NRL Report No. B-2077

Report of Test

Switch, Rotary, Type J

Burkaw Electric Company
104 East 29th Street
New York, New York

PLATE 6

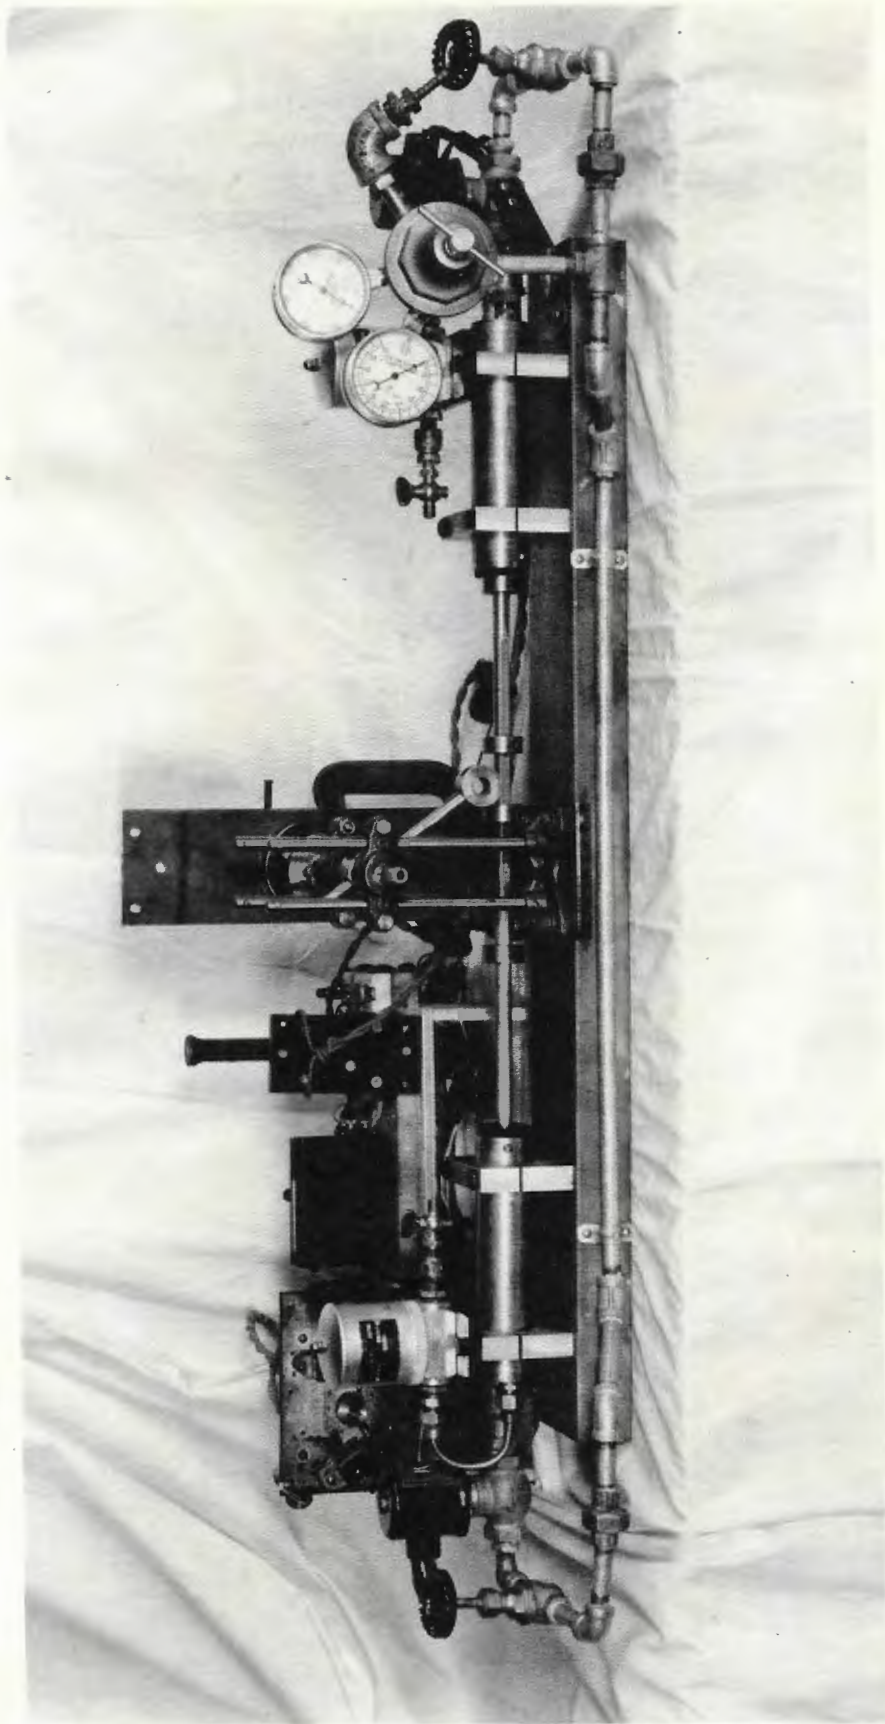
10. The switch was operated by a compressed air mechanism at the rate of 10 operations per minute when carrying a load of 10 amperes, 125 volts, 60 cycles, 0.5 power factor. The transfer (45° rotation of the switch handle) was accomplished in approximately 0.4 second. The driving mechanism is shown by Plate 6. The millivolt drop across the contacts was measured before the test by a Ballentine Laboratories, Inc., Model 300 electronic voltmeter.
